Review of Long-Term Maintenance Plans for the South Jetty, Grays Harbor, Washington

*by Special Subcommittee of the Committee on Tidal Hydraulics and
Coastal Engineering Research Board*

Final report

**Prepared for U.S. Army Engineer District, Seattle
Seattle, WA 98124-2255**

Figure 15. Beach revetment alternative

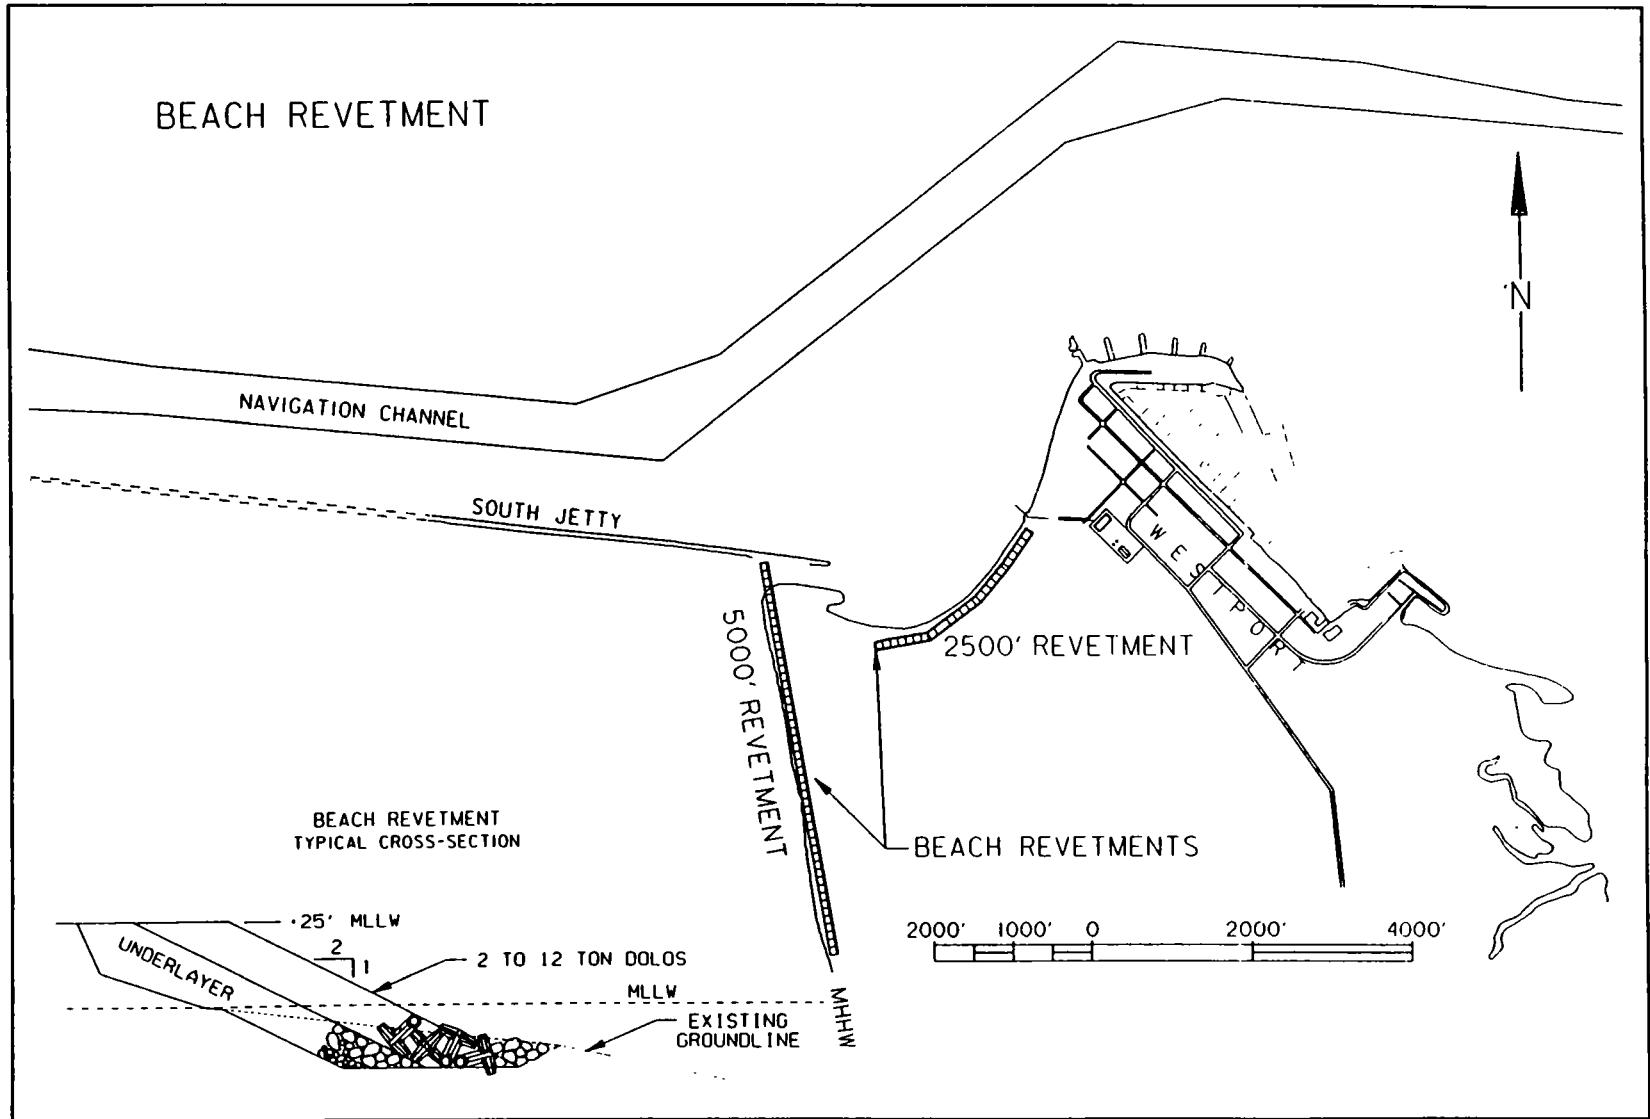
46. This alternative is shown in Figure 15. It includes revetment along South Beach and extension of the revetment in Half Moon Bay. In addition to a very high initial cost, erosion of sand at the base of the revetment down South Beach would cause continuing requirements for expensive maintenance.

Figure 16. South jetty extension and revetment alternative

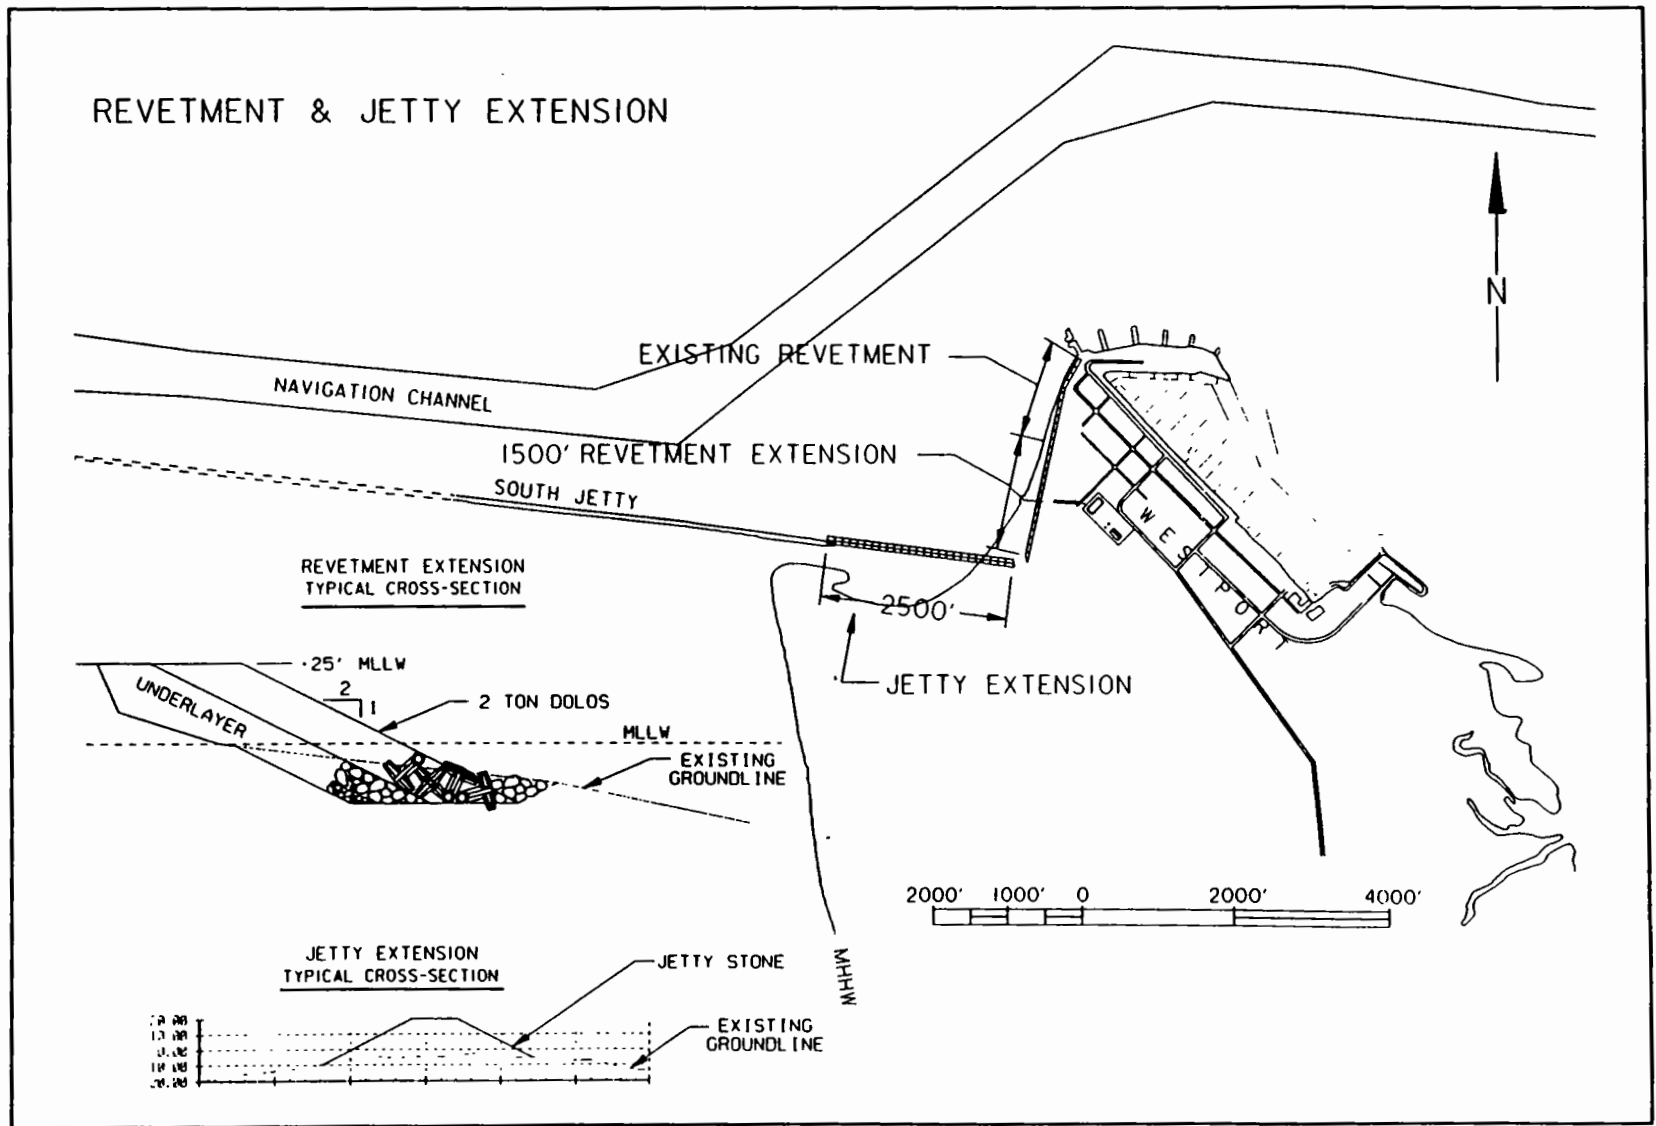
47. This alternative is shown in Figure 16. It includes a 2500-ft eastward extension of the jetty to the junction of a 1500-ft southward extension of the Westport revetment. Protection against erosion in the Half Moon Bay area and of Point Chehalis against waves and currents in the entrance would be provided. This plan would also provide assurance that the entrance channel would not be captured by South Beach erosion in the breach area. Curvature of the jetty near its junction with the revetment extension to provide a smooth alignment along the channel bend would reduce construction and maintenance costs. No means of reducing erosion of South Beach is shown.

Figure 17. Spur groin alternative

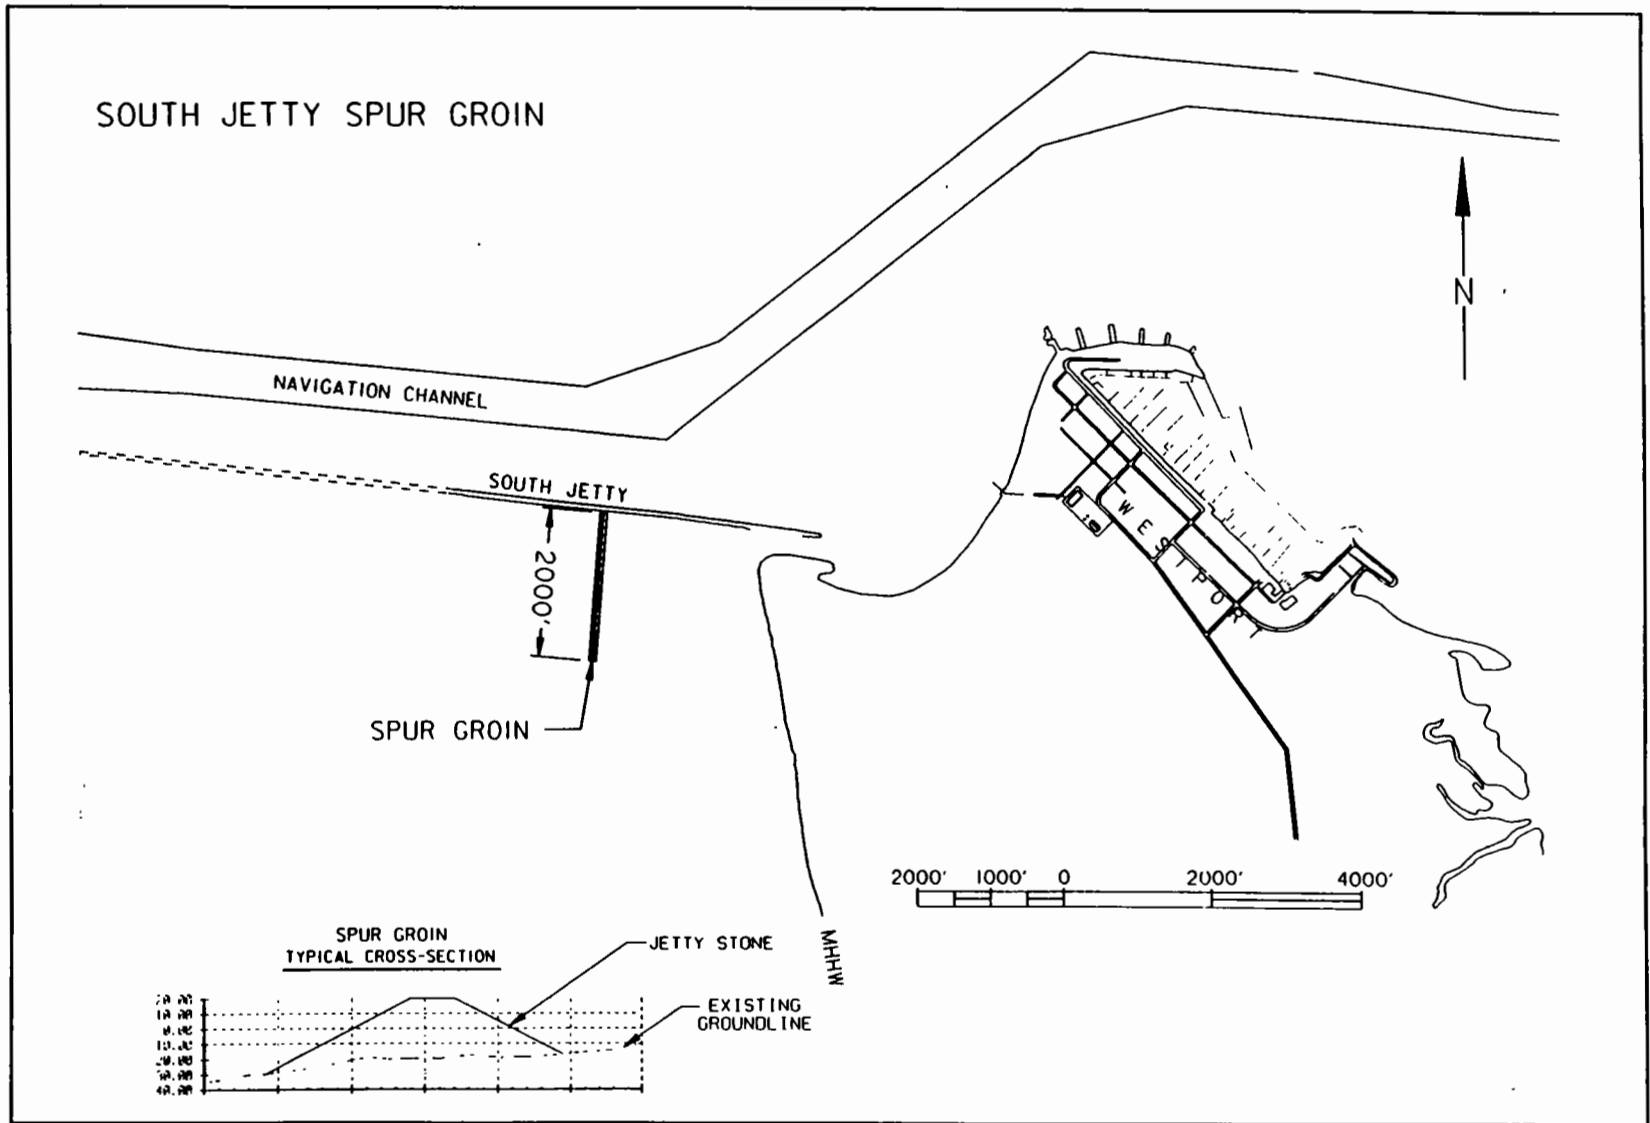
48. This alternative is presented in Figure 17. It includes a 2000 ft groin perpendicular to and on the south side of the South Jetty located about 2000 ft from its east end. No direct closure of the breach is indicated; however, the intent of the groin is to interrupt the seaward current along the jetty and to facilitate accumulation of sand in the breach area and out along the south jetty. This alternative could provide long term protection of the jetty but would require expensive maintenance. It would not diminish erosion in Half Moon Bay. Its efficacy depends on a supply of sand from the south, possibly augmented by placement of dredged material. Design of such a groin should include computations of northward littoral transport and possibly a physical model study to determine optimum location and length of the groin.

Figure 18. South jetty reinforcement alternative

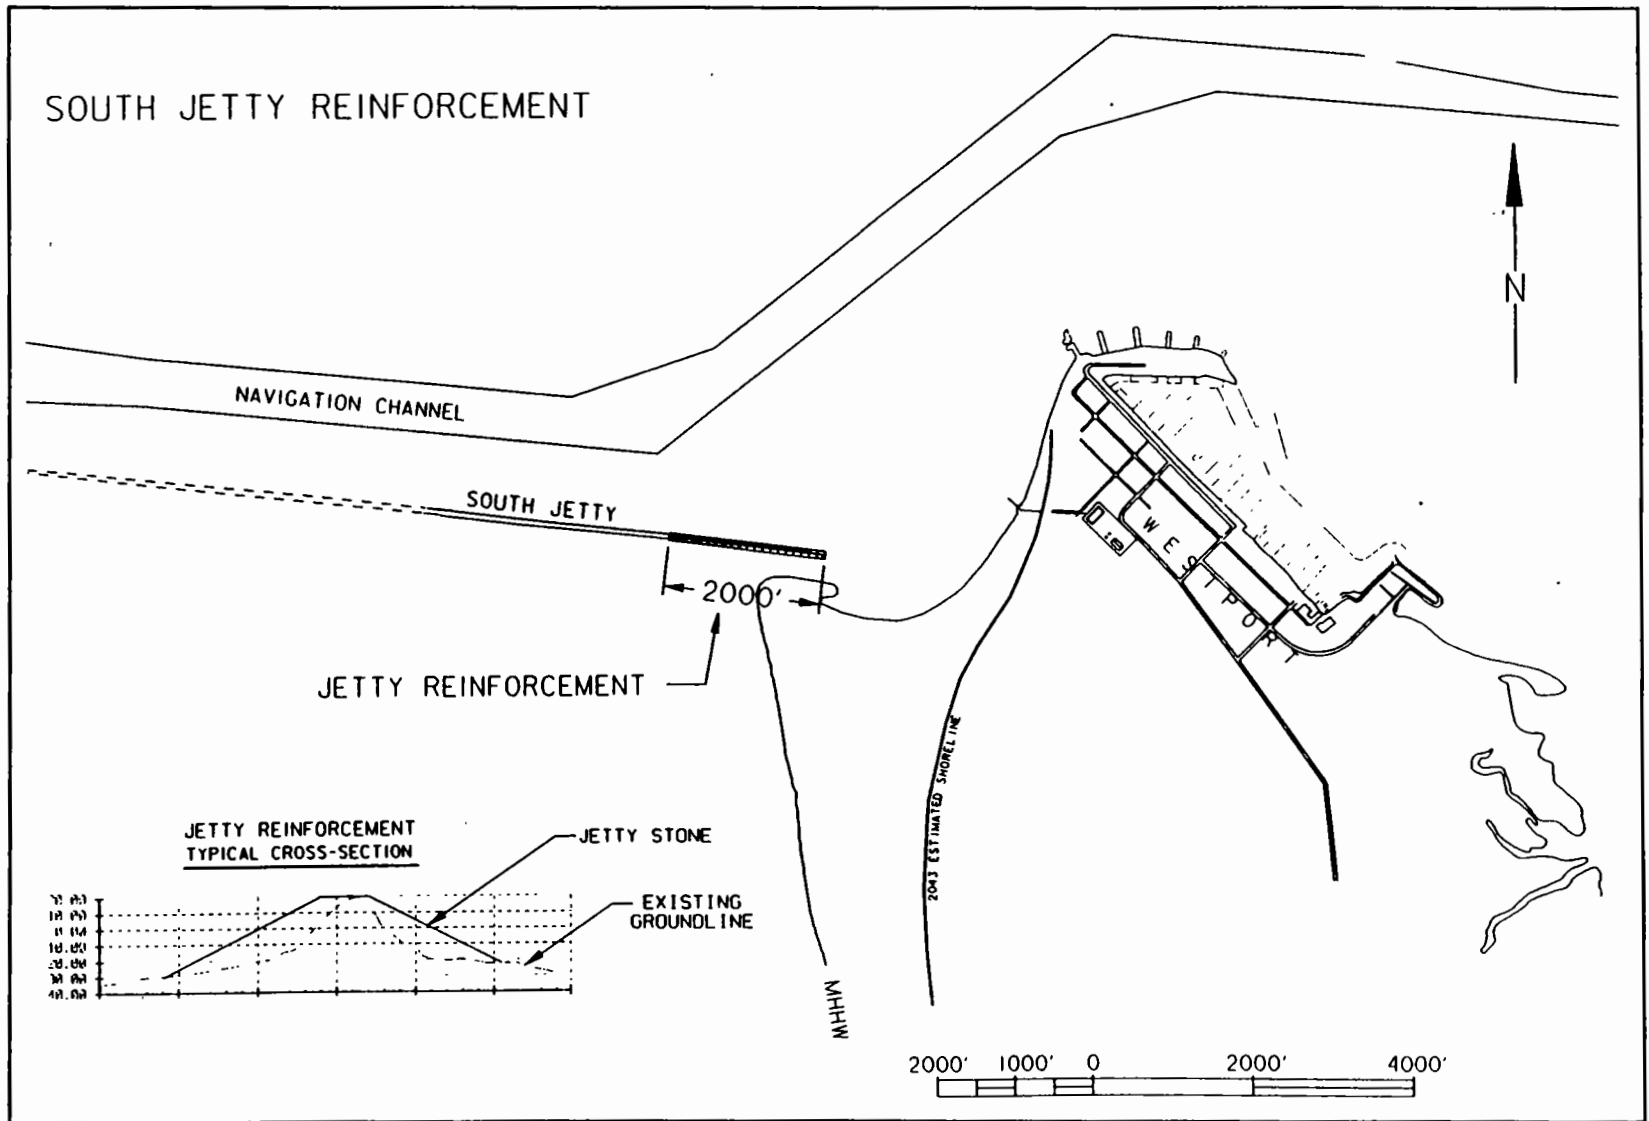
49. This alternative is presented in Figure 18. It includes reinforcement of 2000 ft of the east end of the south jetty. It would maintain stability of the structure in the presence of continuing erosion of South Beach and Half Moon Bay. Continuous monitoring of the beach would be required, and risk of capture of the navigation channel by erosion of the breach would persist.

Figure 19. Nearshore berm alternative

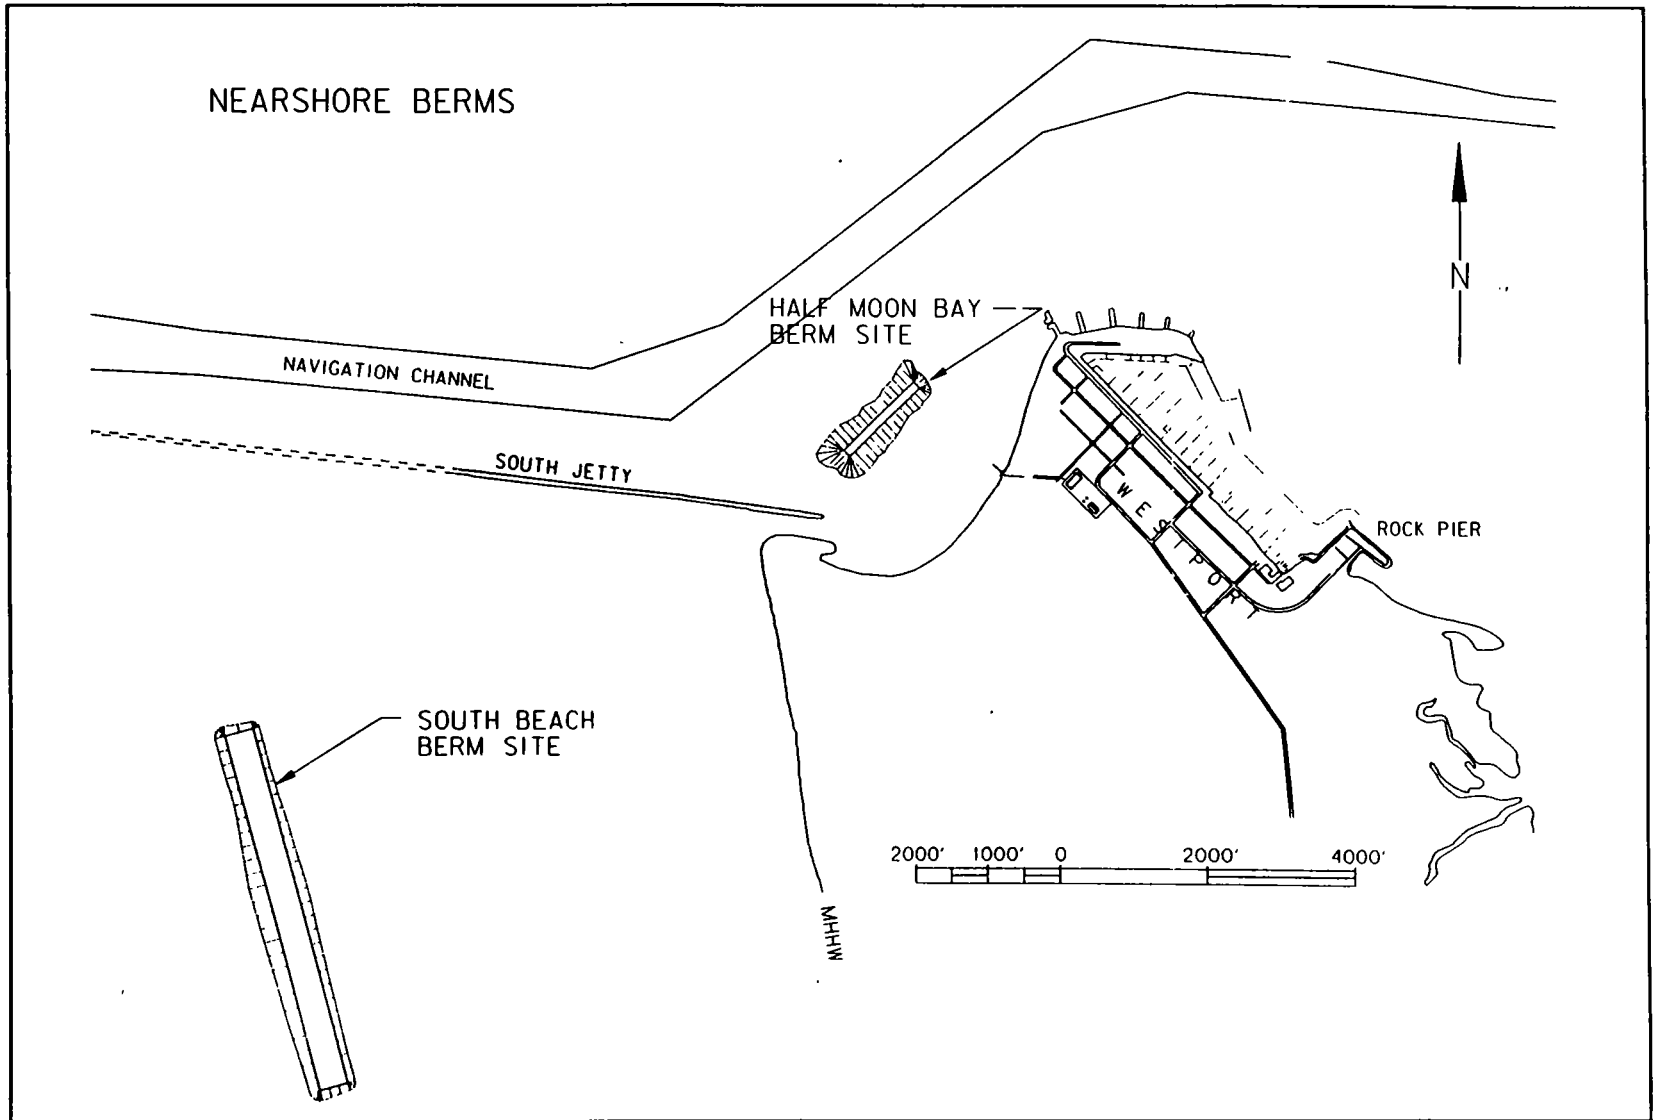
50. Annually resupplied nearshore berms shown in Figure 19 would be placed in Half Moon Bay and near the north end of South Beach. The purposes of these berms would be to reduce wave action and supply sand to the beaches. Up to 500,000 cubic yards a year of sandy dredged material could be placed between the -20 and -40 ft contours near South Beach. The berm would cover an area 5000 ft long by 500 ft wide. An initial berm 2000 ft long containing 385,000 cy of sand was placed at the 40-ft contour during September and August, 1993, and an additional deposit is planned at the 30-ft contour in September, 1994. An initial 185,000 cy berm was placed in Half Moon Bay in 1992 and an additional 200,000 cy was added in May, 1994. Placement of these berms costs little above the cost of the previous disposal operations, and the practice should be continued to retard shoreline erosion.
